Mercedes-Benz USA, LLC
A Mercedes-Benz AG Company

RE: Request for Comment (RFC): *Advanced Driver Assistance Systems Draft Research Test Procedures*, NHTSA Docket No. 2019-0102, 84 Fed. Reg. 64405 (November 21, 2019)

Figure A8. S3 path details, near-miss timing.

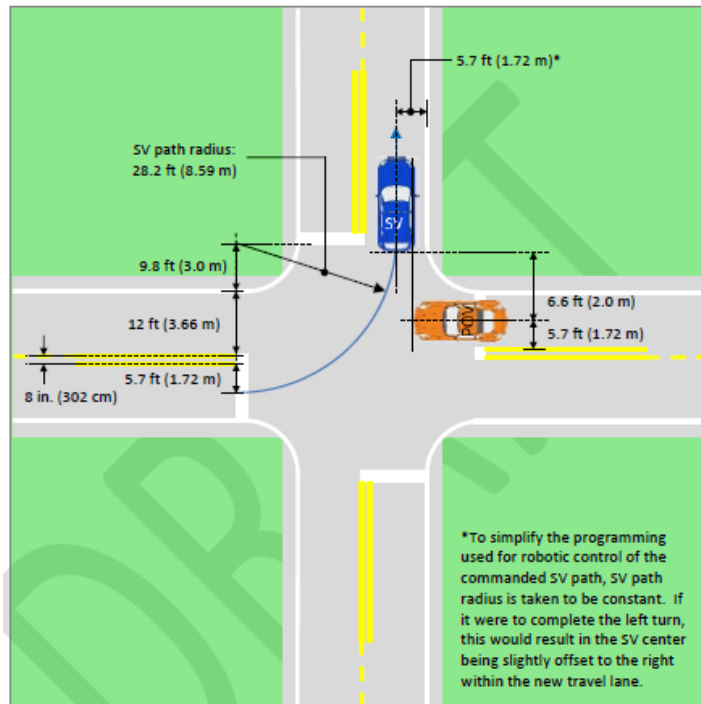
The Intersection Safety Assist protocol defines the left turn path as one radius (image below). While this may be simpler to perform in the tests, the results may not accurately reflect a real left turn scenario.

Figure 8-6: CCFtap scenario paths definition

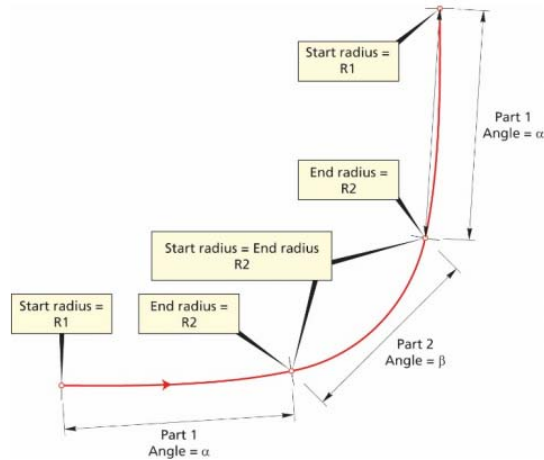
EuroNCAP depicts a left turn in the AEB C2C Version 3.0.2 protocol from January 2020. The path can be seen in the image below. This path is a combination of radii and clothoids, and those even depend on the speed the vehicle is traveling. We would recommend using a natural left turn path (such as EuroNCAP’s model) or one that is based on driving behaviors within the USA. A naturalistic driving study may need to be performed in order to validate the trajectory.
